METROPOLITAN GOVERNMENT OF NASHVILLE AND DAVIDSON COUNTY

STAFF RECOMMENDATION
2405 Belmont Boulevard
July 31, 2012

Application: New construction-addition, Partial demolition
District: Belmont-Hillsboro Neighborhood Conservation Zoning Overlay
Council District: 18
Map and Parcel Number: 10416029500
Applicant: Manuel Zeitlin, architect
Project Lead: Robin Zeigler, robin.zeigler@nashville.gov

2 SITE PLAN - PROPOSED
1/16" = 1'-0"

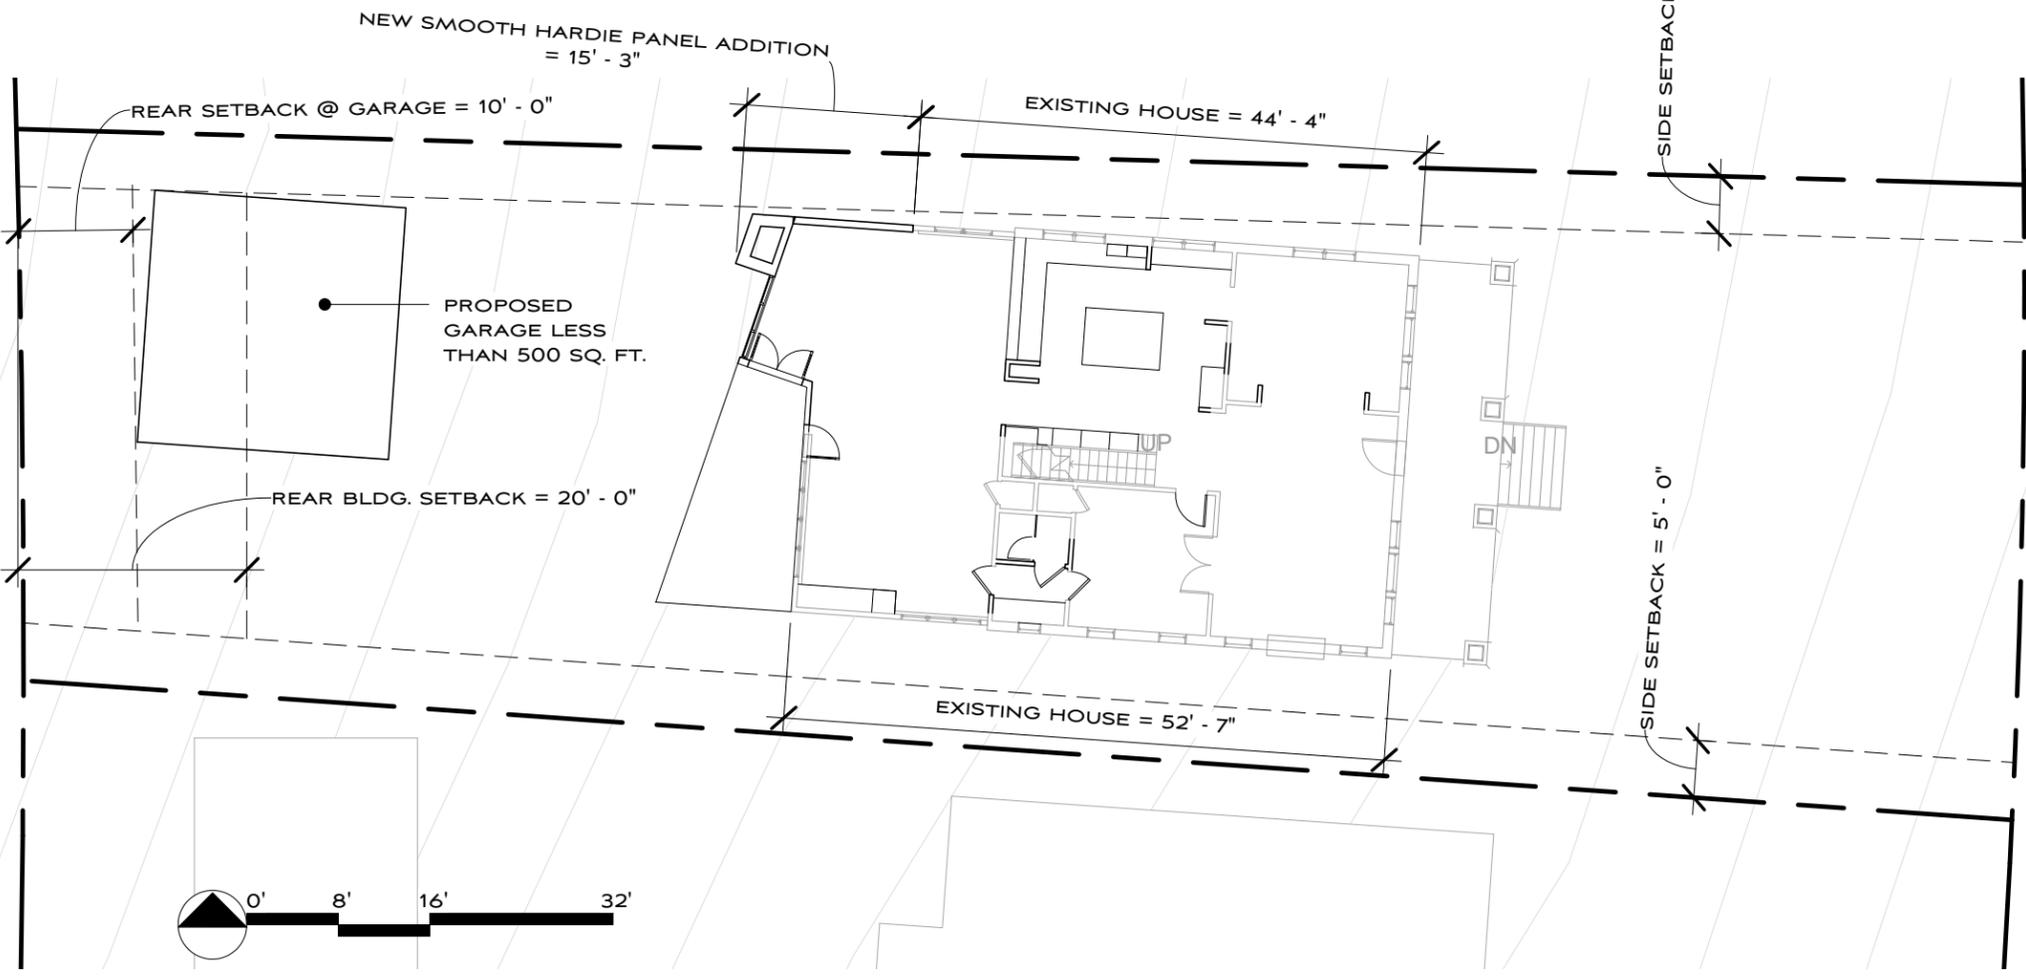
Location & Orientation: The proposed addition is located to the rear of the building. It includes a second level on the left side over an existing one-story addition that will be essentially flush (with the exception of the change in material) with existing side wall. On the right, the addition will be two-stories, also proposed to be flush with the existing wall. According to the design guidelines, two-story additions should sit in a minimum of two-feet (2') to help distinguish from the new from the old and to lessen the impact of the mass of the addition on the existing house. Since the left side of the addition is over an existing portion of the house, no inset is recommended; however, staff does recommend that the addition sit in two feet (2') on the right side.

from the new; however, the massing of the two-story right side is heavy compared to the existing one and one-half story house. The typically required two foot (2') inset would provide a more appropriate scale; therefore, Staff recommends a two-foot (2') inset on the right side for the project to meet II.B.2.a.

Setback and Rhythm of Spacing: The addition fits within the rear and side setbacks required by bulk zoning. The front setback will not be affected. The addition follows the existing lines of the house and does not extend beyond the side walls. Staff finds that the project meets Section II.B.c.

- The applicant provide information about the material, design and dimensions of masonry, foundation, windows, doors, roofing, trim and railings; and
- The right side sits in from the existing side walls by a minimum of two feet (2').

A102

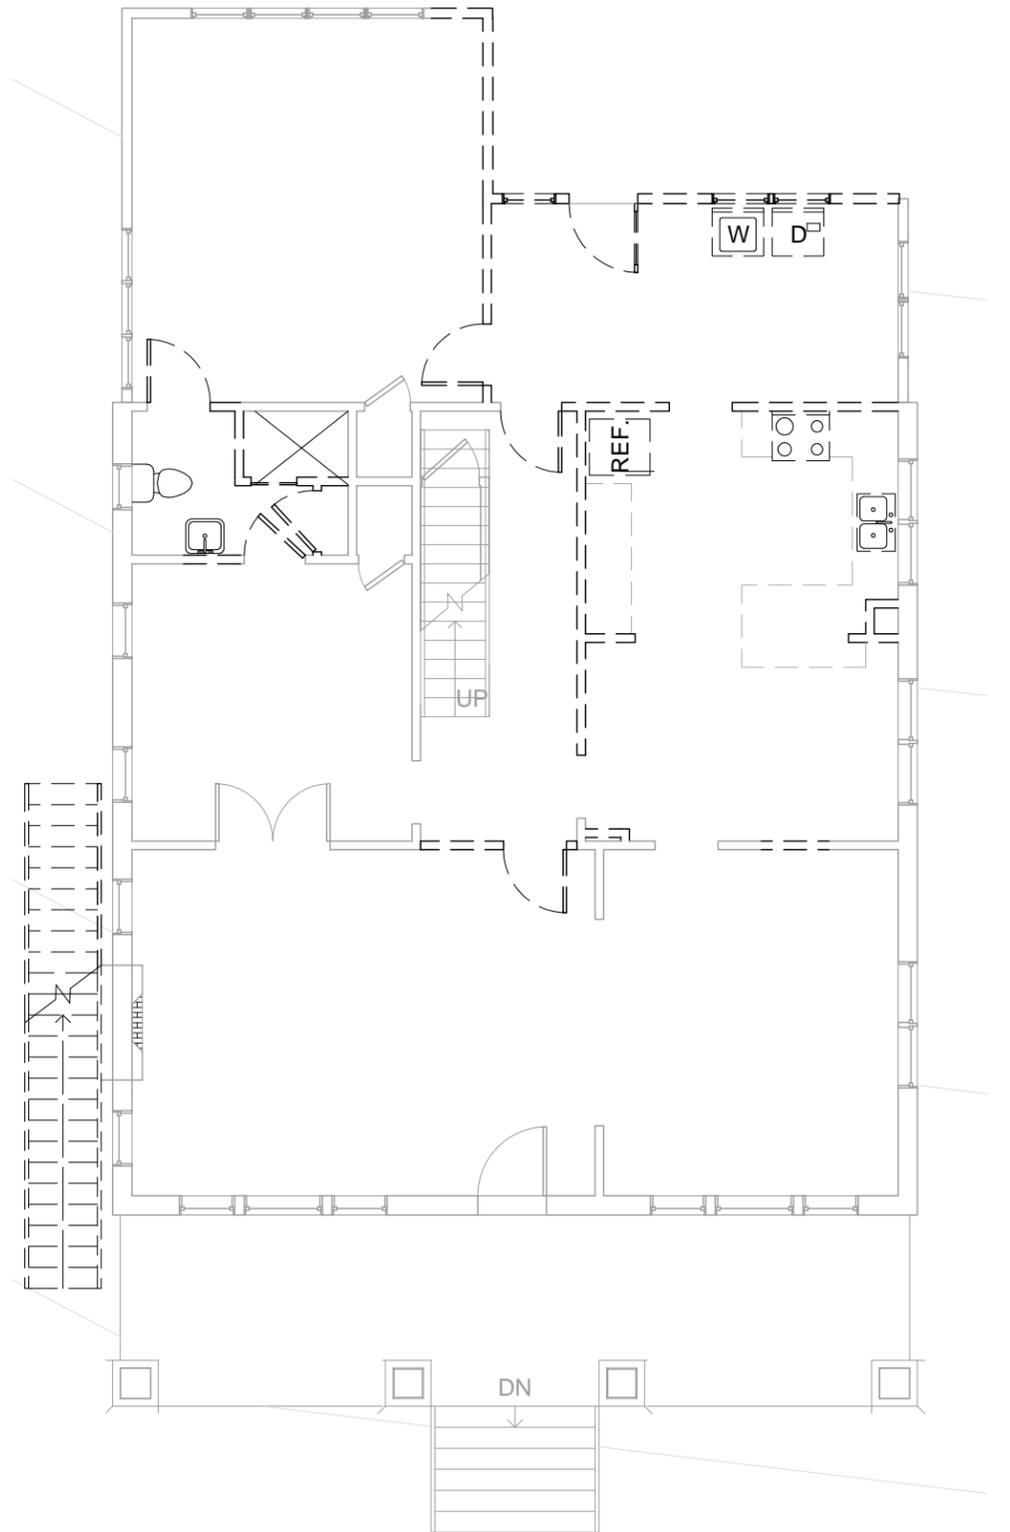
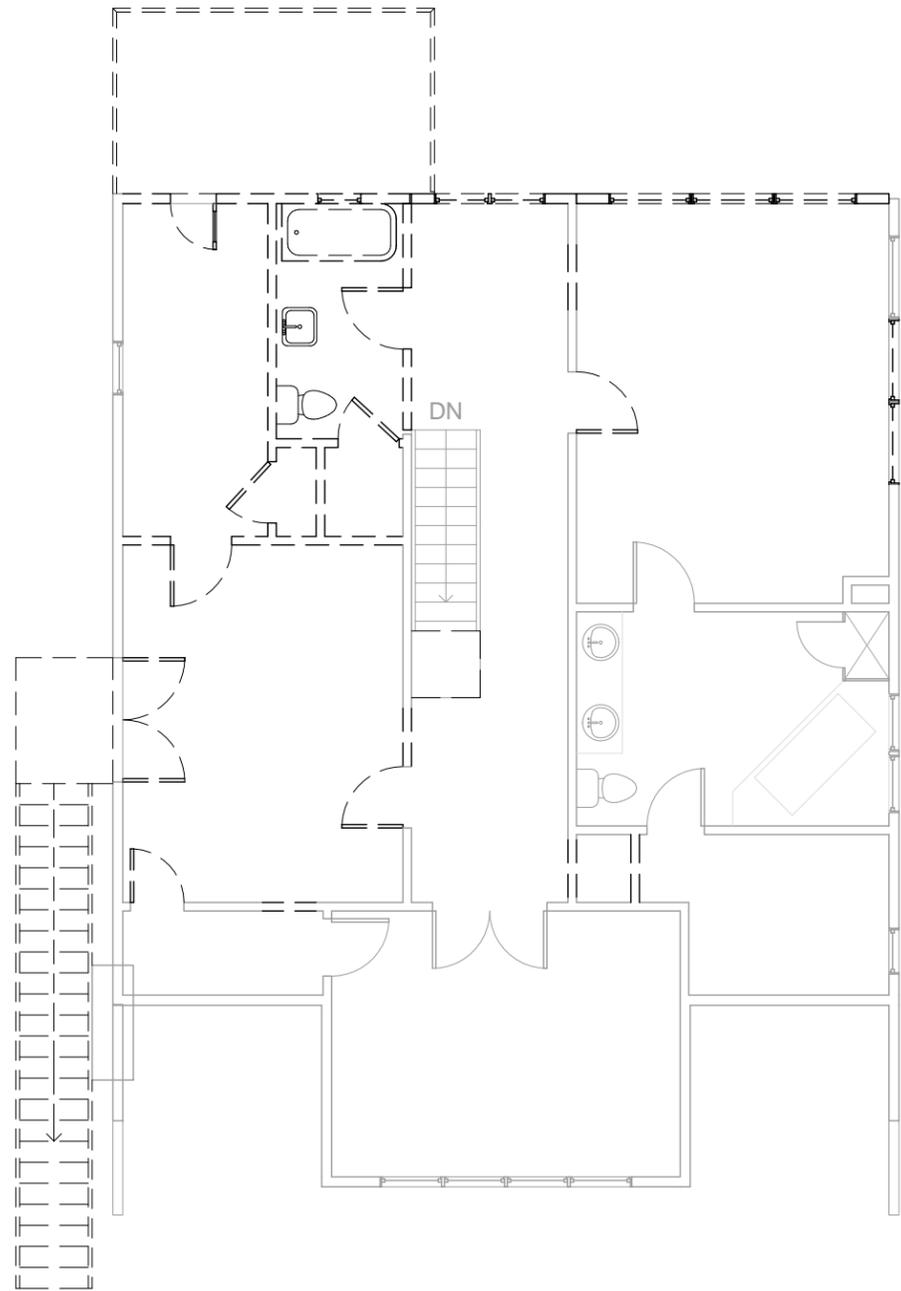
Demolition: The existing accessory structure does not add to the historic character of the district because it cannot be seen from the public right-of-way. It is not large enough to accommodate modern vehicles or situated in a manner to accommodate any vehicles because of the grade. In addition, it is in poor condition. Denial of demolition would result in an economic hardship since the accessory structure is not usable as a garage and, because of the size, grade and layout of the lot, a new garage cannot be constructed without its removal.

Staff finds that demolition of the accessory structure to meet section III.B.2.c. A new garage is not a part of this application but is planned.
